SUBDIVISION COMMITTEE
METROPOLITAN AREA PLANNING COMMISSION

STAFF REPORT
(Preliminary Plat)

CASE NUMBER: S/D 98-25 - SCHUETTE'S FIRST ADDITION

STAFF REPORT
(Final Plat, Preliminary Plat approved 3/19/98)

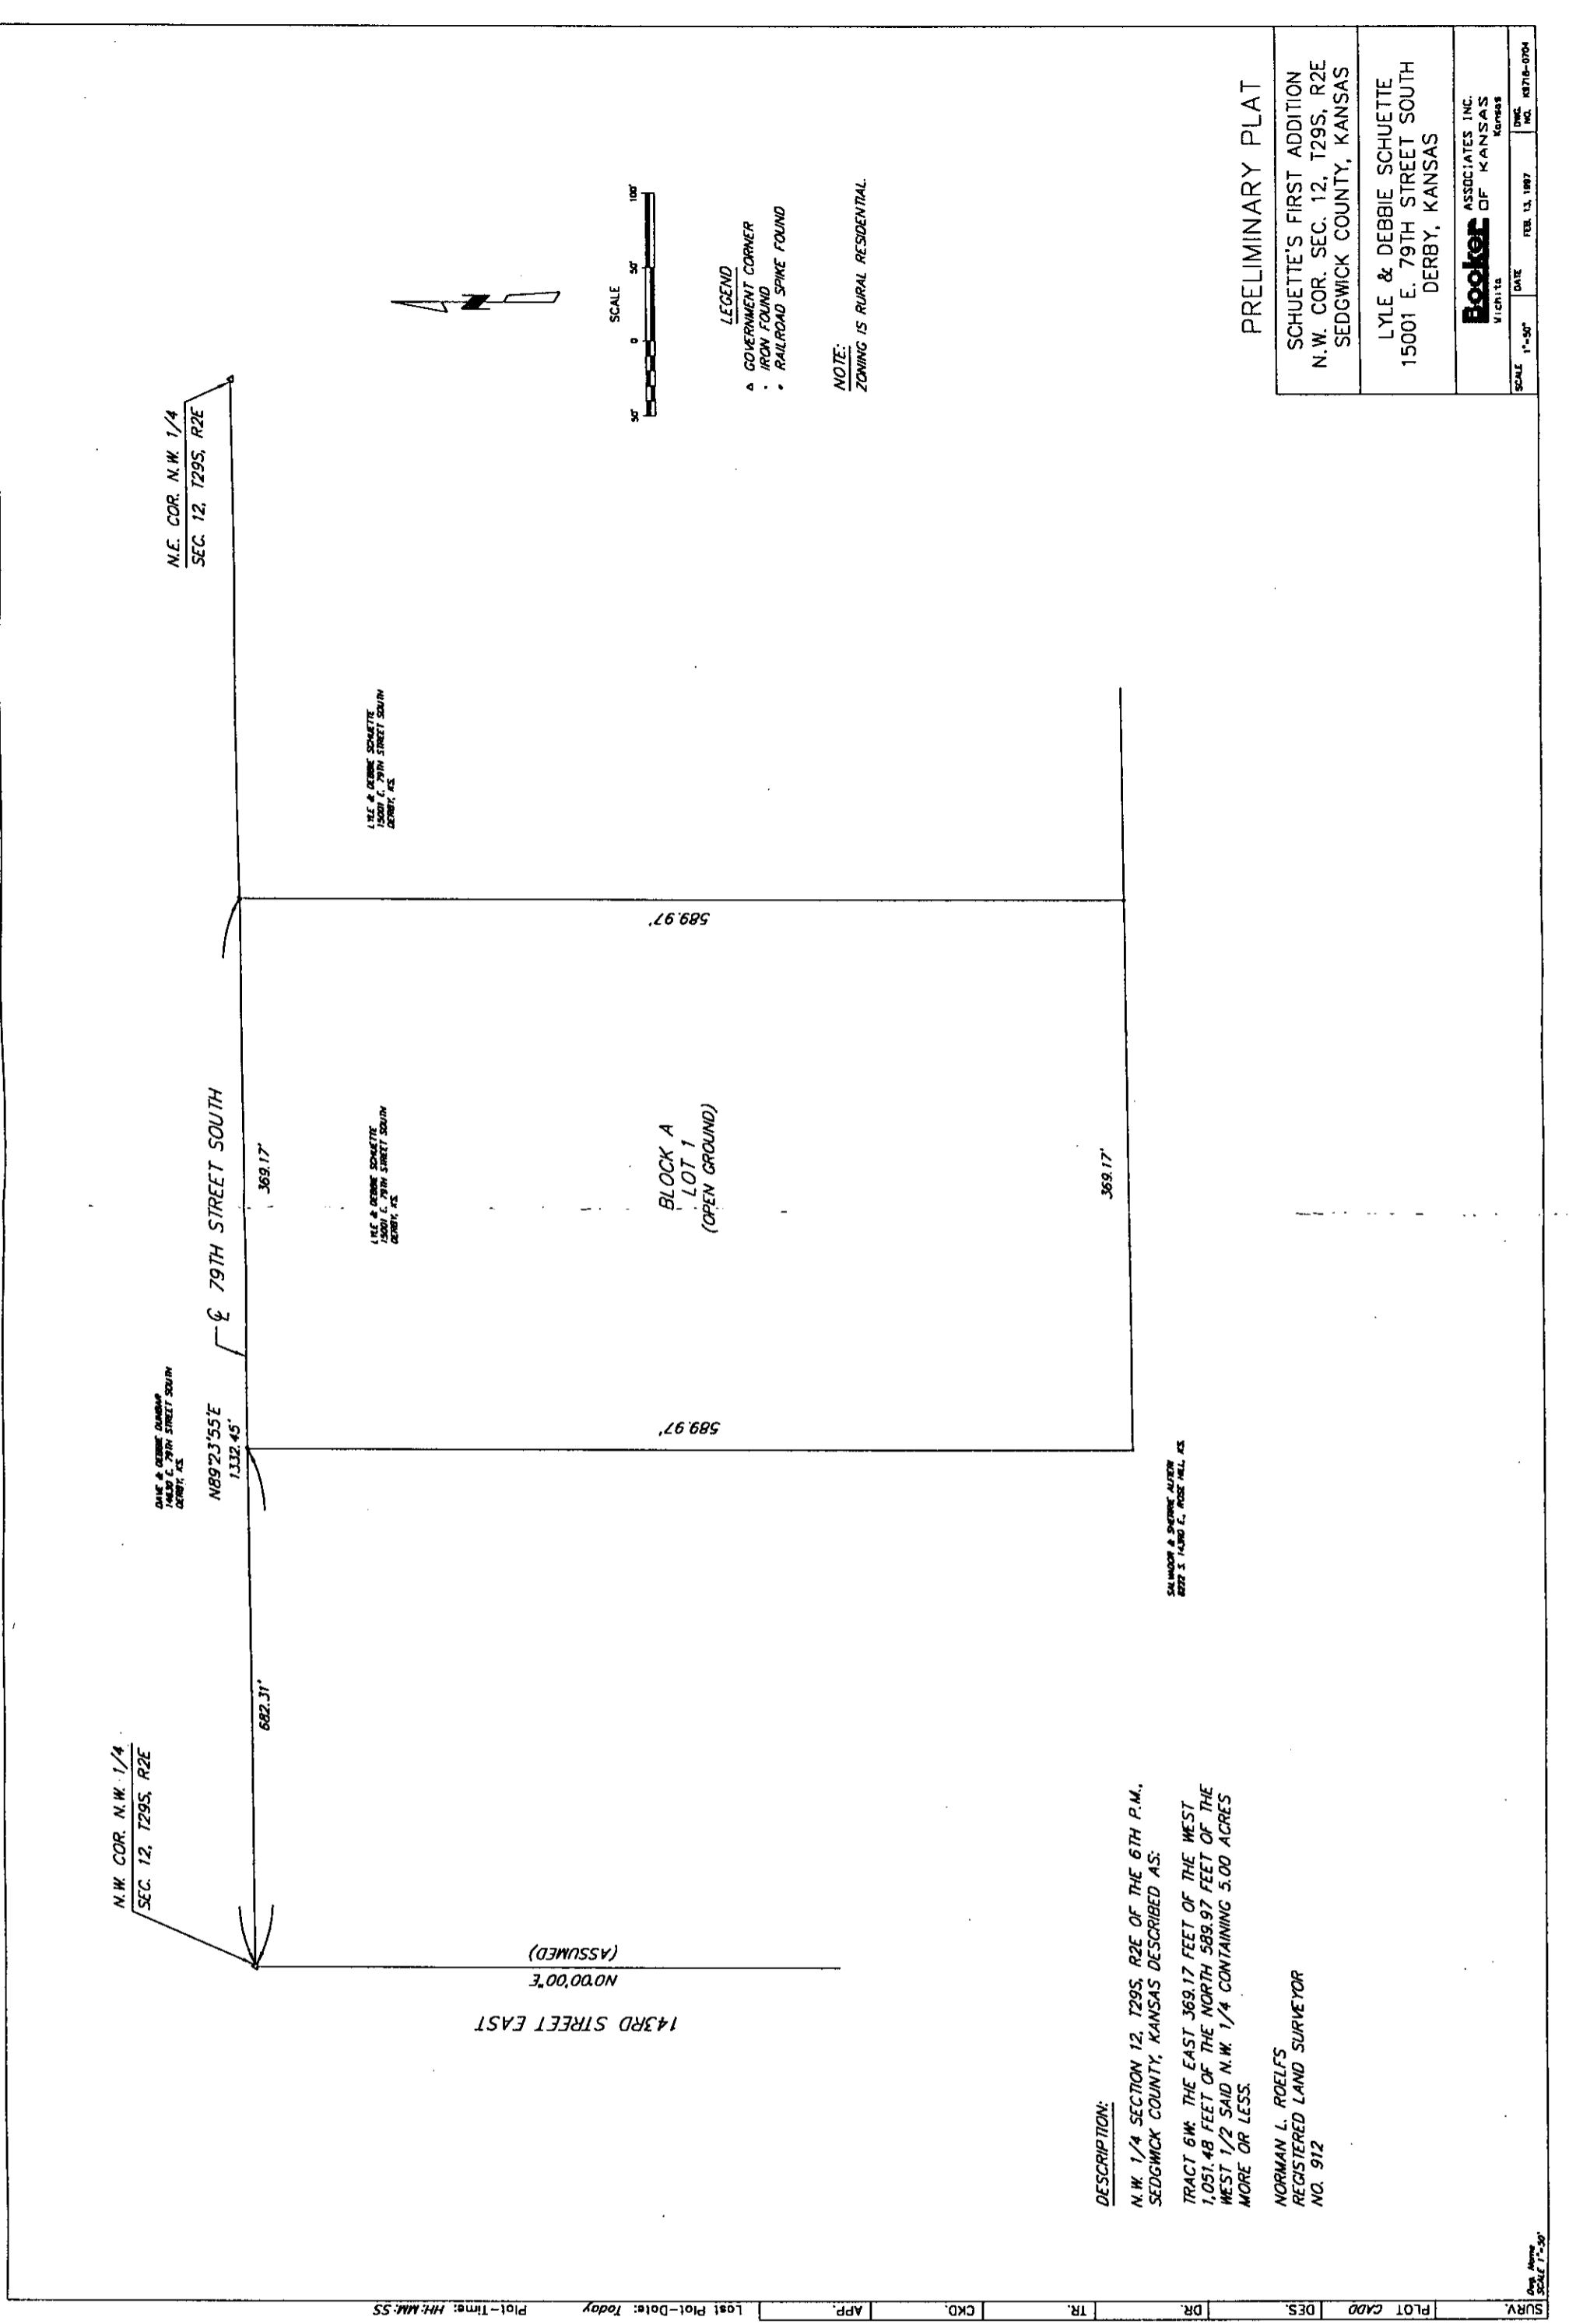
- D. **The face of the plat and the plattor's text should denote a contingent dedication of a 47.69 foot street right-of-way along the western line of the plat (to connect with the 22-foot strip adjoining this plat to the west totaling a 70-foot future street right-of-way). A temporary right-of-way at the terminus for a turnaround is also needed. The plattor's text shall denote that the contingent street dedication shall become effective upon the platting of any adjacent subdivision. Applicant will meet with County Engineering to further discuss this issue.**

Pursuant to the preliminary plat review, the applicant purchased the adjoining property to the west and the final plat encompasses the 22-foot strip noted above. The final plat does not indicate the 70-foot contingent right-of-way dedication as requested.

- E. **County Engineering** needs to comment on the status of the applicant's drainage plan and the need for any minimum building pad elevations. **A floodway reserve is needed to cover the existing waterway along the front 80 to 120 feet.**

The final plat does not denote the floodway reserve as requested.

- F. The north line of the plat should be located 50 feet from the centerline of 79th Street North. The face of the plat and the platlor's text shall note the dedication of street to and for the use of the public. **An additional 20-foot of right-of-way is required to be dedicated.**

This dedication shall be indicated on the final plat tracing. The north line of the plat should be denoted by a solid line.

Access control has been depicted as requested.

PRELIMINARY PLAT

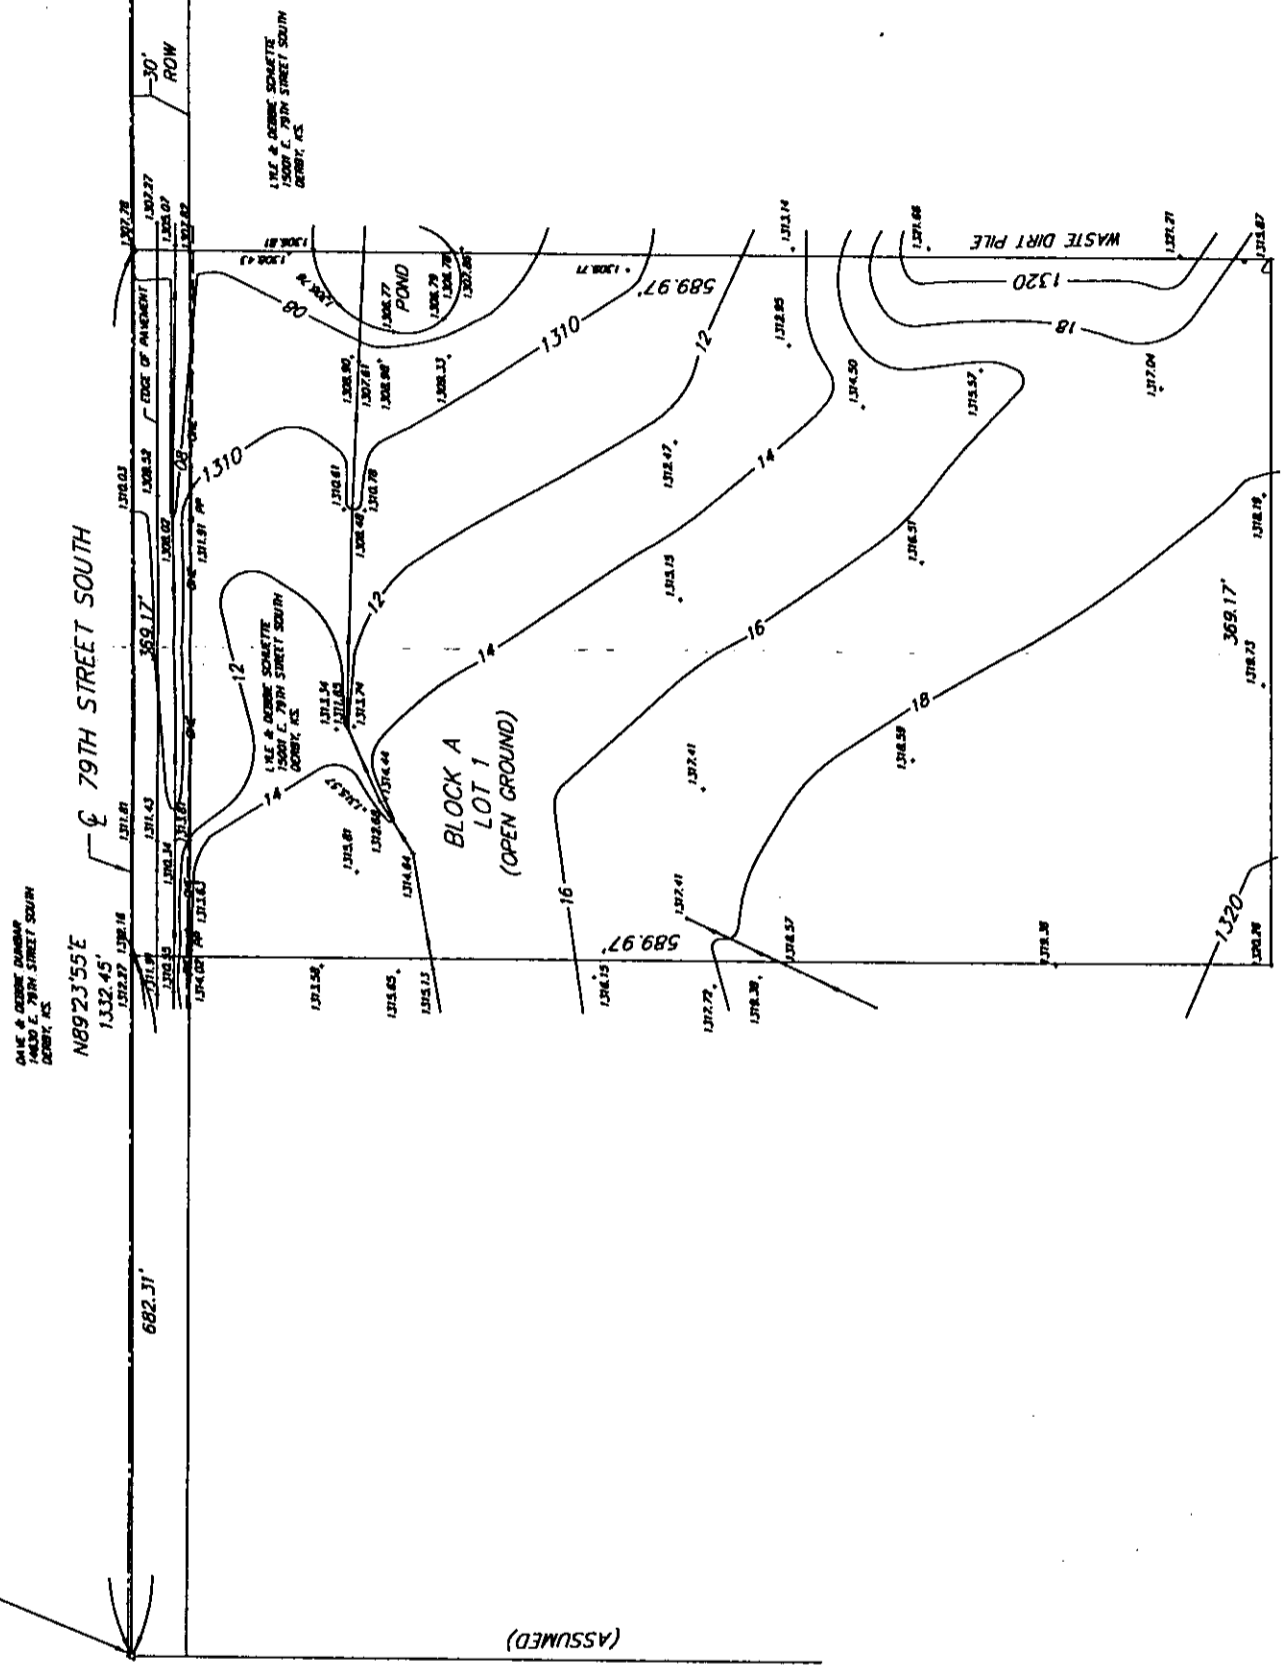
- D. The face of the plat and the plat's text should denote a contingent dedication of a 35-foot half street right-of-way along the western line of the plat along with a temporary right-of-way at the terminus for a turnaround. The plat's text shall denote that the contingent street dedication shall become effective upon the platting of any adjacent subdivision.

- G. The applicant needs to revise the distances on the drawing (1332.45') to correspond with the legal description, in addition to depicting them to scale.

- H. The final plat shall denote access control except for one opening along 79th Street South.
